Equipment Leaks of VOC in Natural Gas Production Industry — Background Information for Promulgated Standards

Background Information
and Final Environmental Impact Statement
for Equipment Leaks of VOC from Onshore Natural Gas Processing Plants

Figure 5-1. Cost Effectiveness versus Plant Size for Small Plants

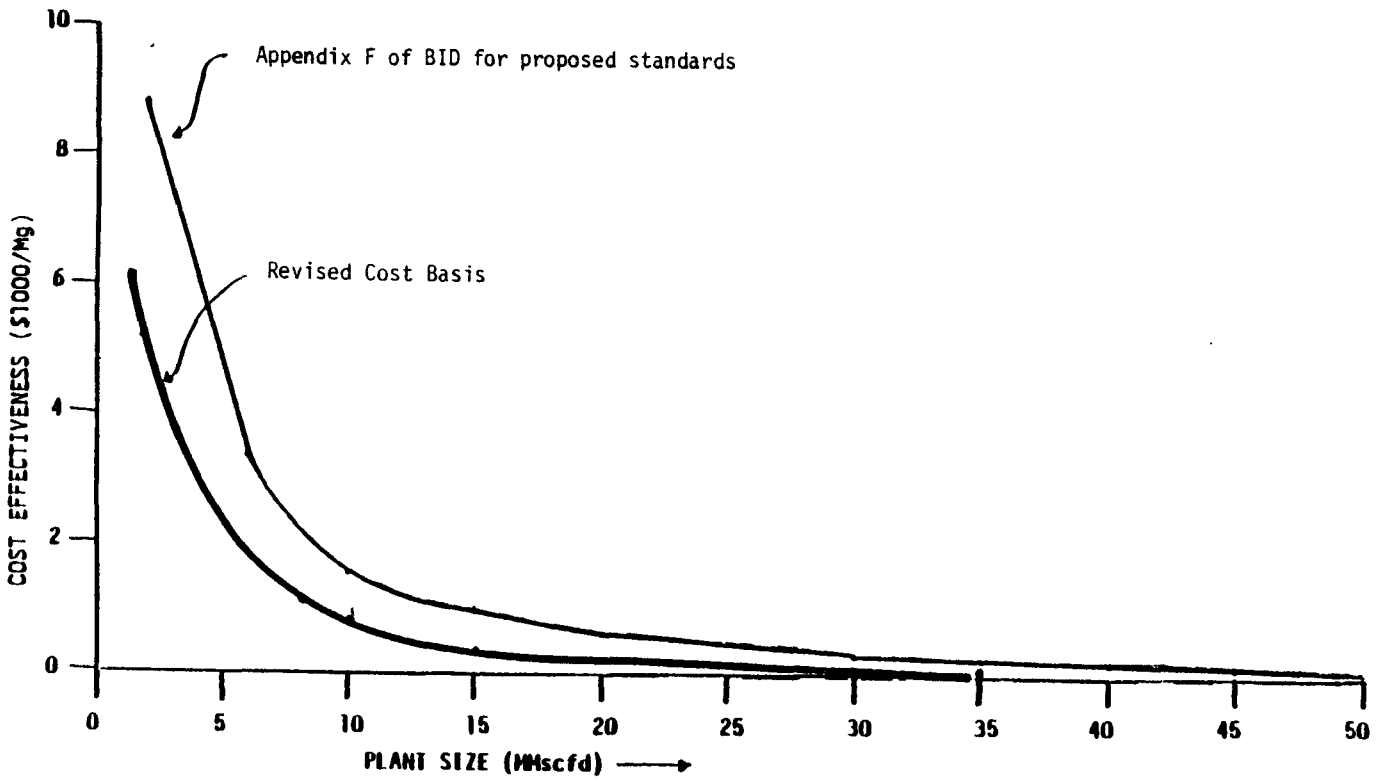
Commenter IV-D-33 requested that EPA consider the extra travel time in getting to remote plant sites in setting the cutoff and the effect of extreme climatic conditions on travel schedule. In addition, the commenter stated that many gas plants with capacities of 10 MMscfd or less, whether they fractionate or not, are only partially attended or unattended. The commenter cited as examples two types of gas plants, straddle plants and casinghead plants, that differ in their staffing requirements and profitability because of their different numbers of pieces of equipment and feed rates. The commenter further stated that if his company hires an outside contractor, the recordkeeping and reporting requirements alone would be sufficient to warrant hiring a person at a cost of about $36,000 per year for each central office. The commenter concluded that there would be an obvious negative impact on plant efforts to improve manpower productivity.

Response: As presented in Appendix F of the BID for the proposed standards, EPA carefully analyzed the cost effectiveness of routine leak detection and repair programs for small, nonfractionating plants. The cost effectiveness values derived were presented graphically on page F-7 and are reproduced in Figure 5-1 on the next page. The graph in Figure 5-1 shows that the cost per megagram VOC reduced begins to increase rapidly as the plant throughput falls below 10 MMscfd. Therefore, 10 MMscfd represents an appropriate cutoff, and nonfractionating plants processing more than 10 MMscfd are subject to the monitoring requirements of the standards.

Figure 5-1 also shows that the basis for the small plant leak detection and repair programs has been changed slightly since proposal. The primary revision to the cost basis was in changing the instrument cost. The analysis presented in Appendix F of the BID for the proposed standards was based on the assumption that each plant would maintain two monitoring instruments. However, if the monitoring is to be performed by contractors or central office personnel, it is likely that the instrument cost would be distributed among several plants. The revised cost is based on the assumption that the contractor or central office personnel would maintain two instruments but would use these instruments among five plants. Complete details of the revised costs are available in Docket Item IV-B-6.

The cost effectiveness values presented in Figure 5-1 are based on the cost of performing the required leak detection and repair program using either contractor or central office personnel. These costs include travel costs, as well as additional manhours for travel time. Since fractionating plants are more complex than nonfractionating plants, both physically and operationally, plants having fractionation trains are likely to have full-time operating and maintenance personnel available to perform the monitoring program "in house." The costs of such an "in house" program would be greatly reduced from a program requiring expenses for outside personnel and travel; consequently, an "in-house" program would result in a much better cost effectiveness. Fractionating plants are subject, therefore, to the requirements for routine monitoring regardless of capacity.
